Project
37 North Hill

Phase
Planning. [HGY/2022/4430](#)

Client
Michelle and Martin Everitt

4.	Area of Planter proposed for removal (extract and Mark up of submission plans)
	option for bin store with planted lid area 1.3 sqm (reduces lost planting to 3.4 sqm) 
5.	 Portion of planter to be removed.
5.	Views from Street

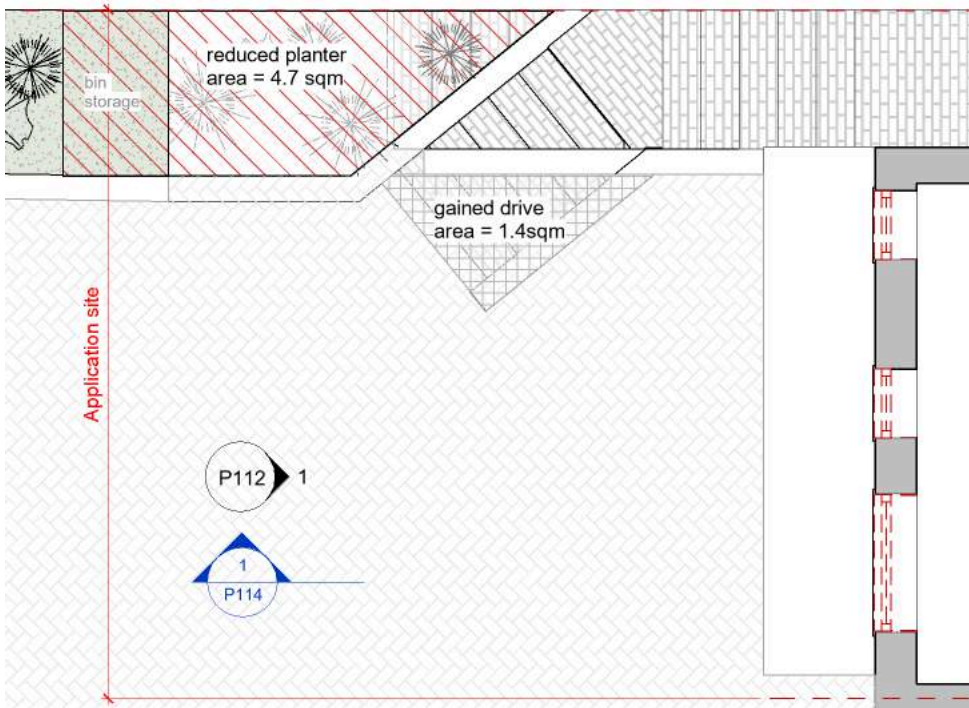
Item	Description – Objection
1.	HIGHGATE CONSERVATION AREA ADVISORY COMMITTEE Comment left on. 26/1/2023 Stance. Object Highgate Conservation Area Advisory Committee has no objection to the proposed changes to the front doorway and downstairs cloakroom etc, indeed that element of the proposals may improve the appearance of these two houses, and better energy performance is to be welcomed. However, we strongly object to the proposal to remove trees and other greenery from the area in front of the house and replace it with even more empty, paved space for parking. This front yard already has a far higher proportion of paved area than almost all nearby houses and is out of keeping with the leafy character of this stretch of North Hill. To remove even more planting and insert an even larger parking area for cars in front of these two houses is completely unacceptable. It would damage the conservation area and also be contrary to national and local policy regarding sustainability, maintenance of tree cover, not contributing to climate change and so-on, and would add to run off problems

2.	Response – to Objection We think the proposal is a balanced approach that does not have a negative impact on the application site, street or conservation area for the following reasons: 1. There are no trees proposed for removal so the proposal has no impact on the ‘maintenance of tree cover’. The nearest significant trees are on the pavement. The smaller tree within the front portion of the retained planter area will be retained. (see last image page 3). 2. The area of the existing planter that is proposed for removal to straighten the stair and create a bin store is 4.7 sqm (cross refer to the plan mark-up overleaf). • 8 sqm of the planter area is retained, the area closest to the street. • The area proposed for removal cannot be seen clearly from the street due to the steepness of the drive. • Healthy plants or shrubs in the removed area of planter can be replanted in the front section. • The lid to the bin store could be planted to reduce the planting area lost to 3.4sqm. • The removal for the bins from the driveway will be a positive contribution to the appearance of the conservation area. Removing the bins from the drive will allow a clearer view of the area of the planter that receives more light where plants and shrubs have been more successful. 3. The photos attached illustrate the quality of the current planting, which is situated behind a high wall and very shadowed.

3.	In addition, and with reference to the Heritage Design and Access Statement that accompanies the application: • The area of the driveway gained by adjusting the steps is 1.4 sqm. This will allow the car to be parked further to the side allowing better access to the proposed central door position. • Adjusting the steps will lessen the impact of the vertical hard surfaces viewed from the street. With the bins moved and clearer views of retained planting the resulting appearance of the street elevation will be softer. • Adjusting the steps is also aimed at improving accessibility and accommodating a car charging point – aligning with policies concerned with lifetime homes and with sustainability.
